Three Mile Island Nuclear Plant, Unit 1 (TMI-1)
Operating License No. DPR-50
Docket No. 50-289
Technical Specification Change Request No. 204

1.0 Proposed Technical Specification Change Request

FIGURE 3.1-2a

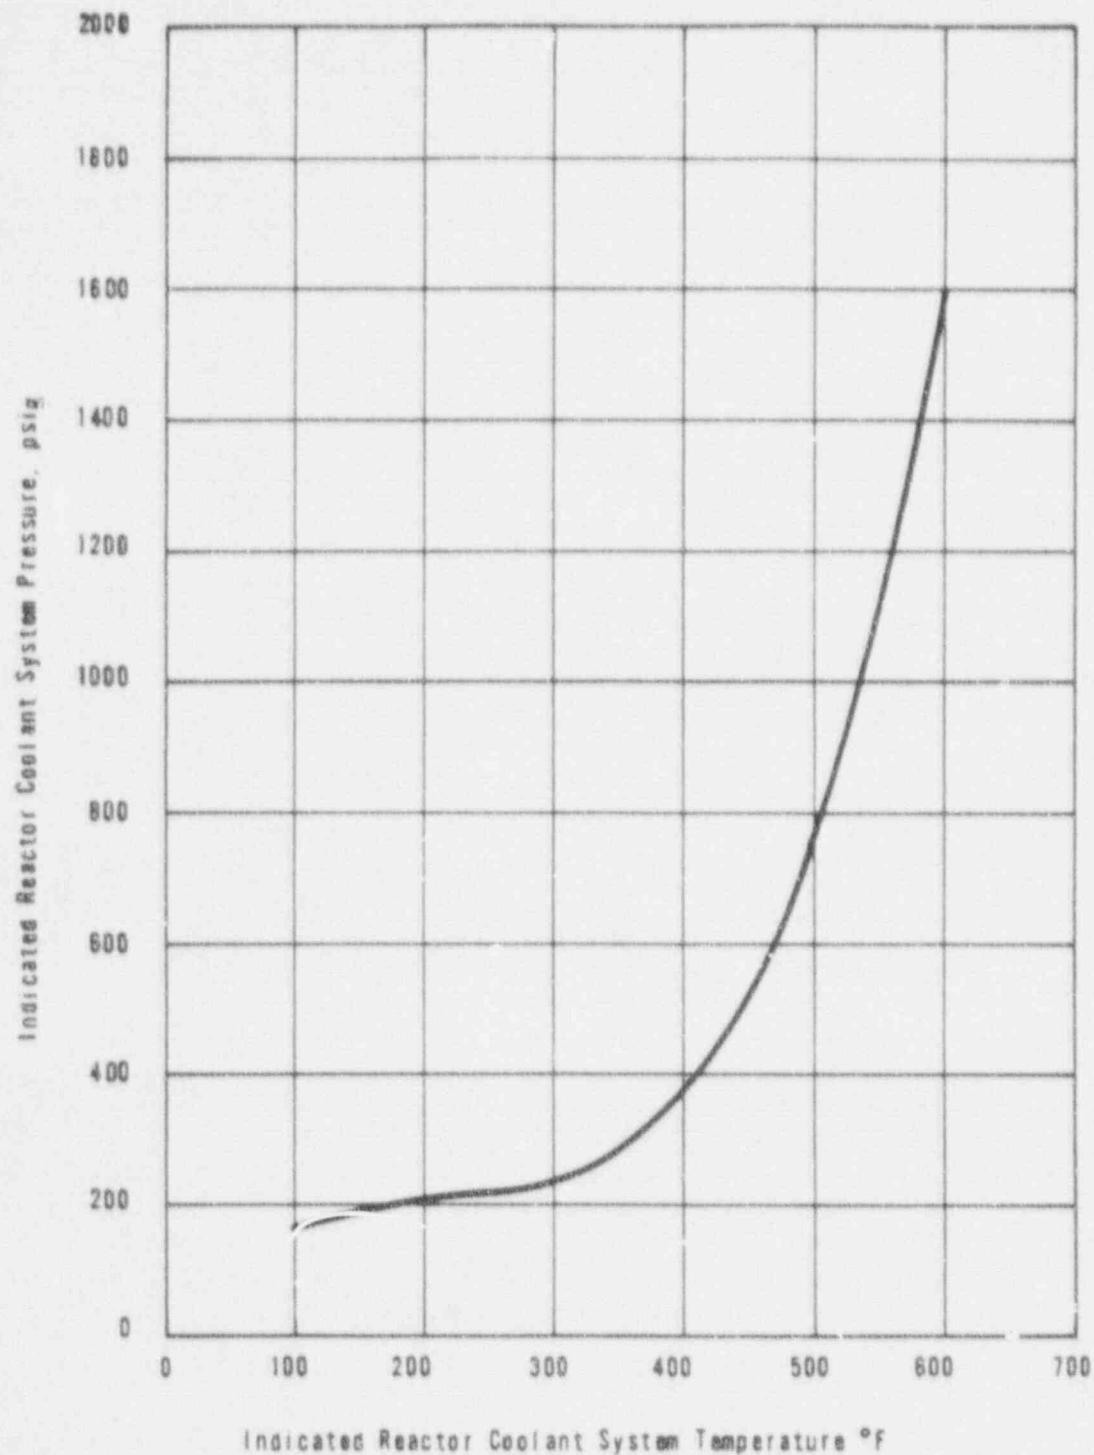
- p ii Reflects changes to pages being renumbered.
- p vii Table of Contents, page numbering added for Figures.
- p viii Deleted, original information moved to p vii.
- p 3-9b Figure 3.1-2a title retyped for clarity
- p 3-18b Pages renumbered due to Figure pagination
- p 3-18c
- p 3-18d
- p 3-18e
